Grandview Reserve Phase 2 Preliminary Drainage Report

July 2024

EDARP Filing No.:

PUDSP236

EXISTING EX1

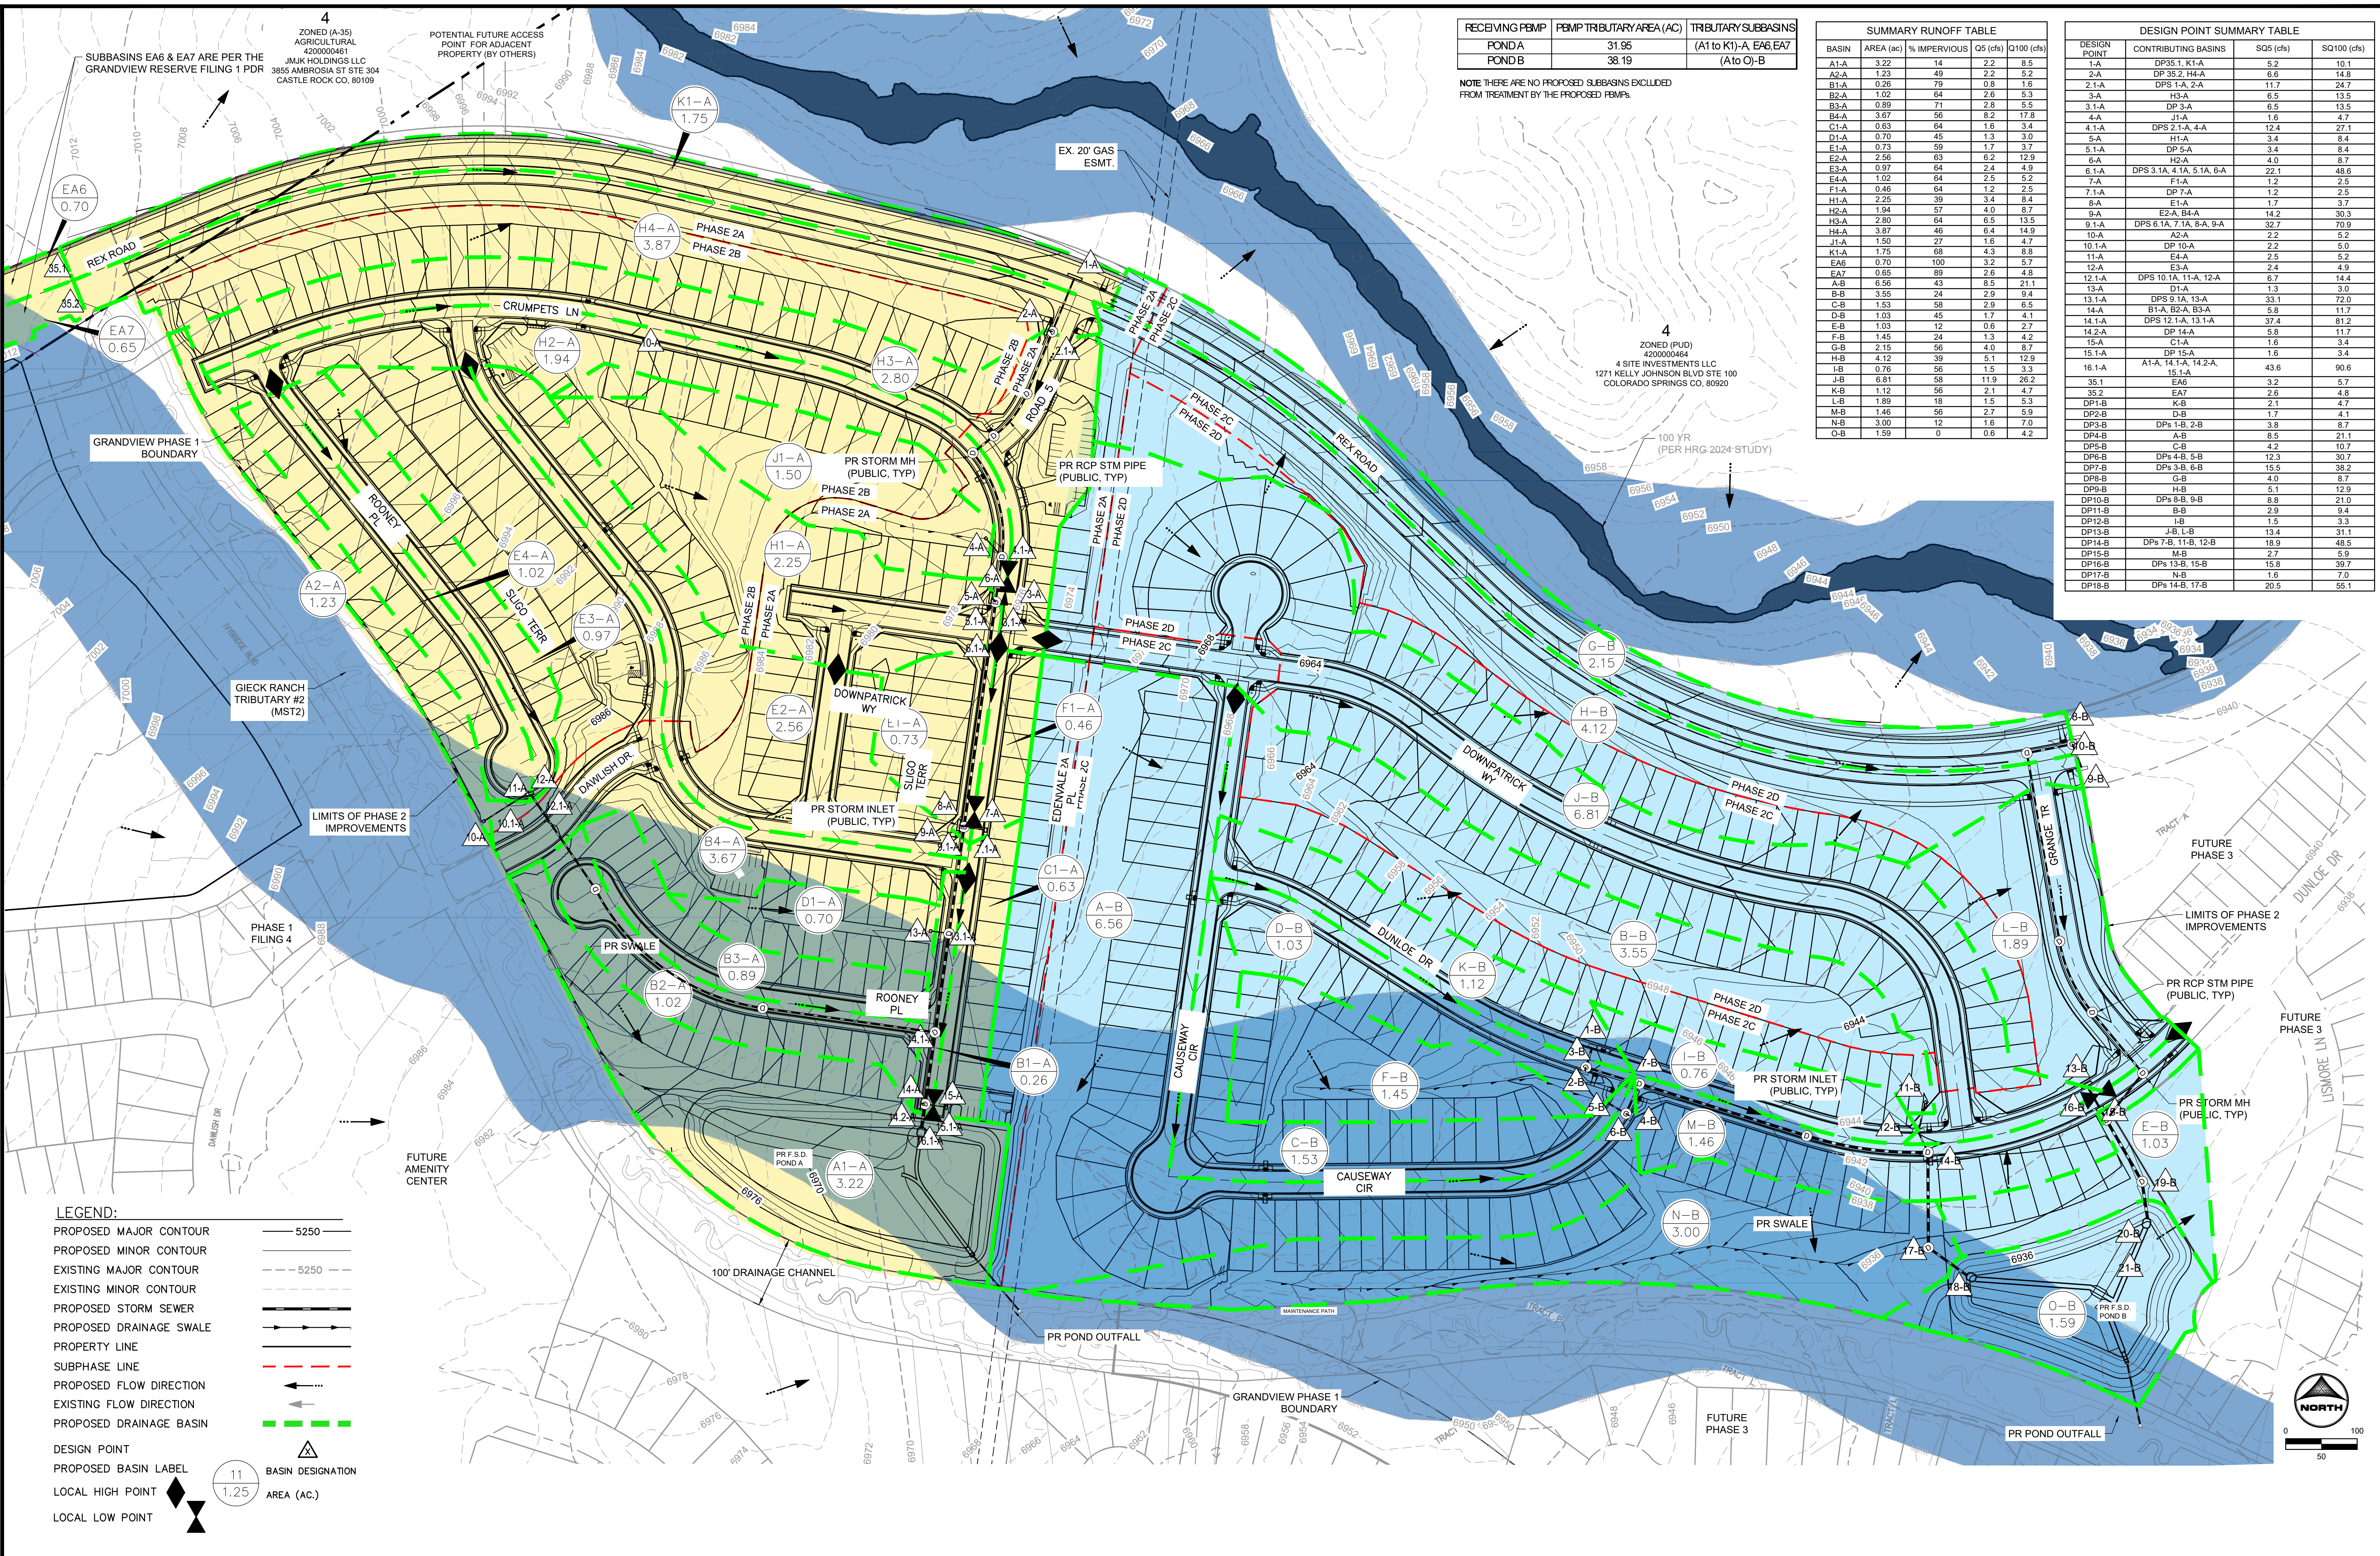
Response acknowledged, however, please provide an existing drainage map, specifically for Phase 2. Include design points that will correspond to pond release locations, so historic flows can be compared to pond release rates.
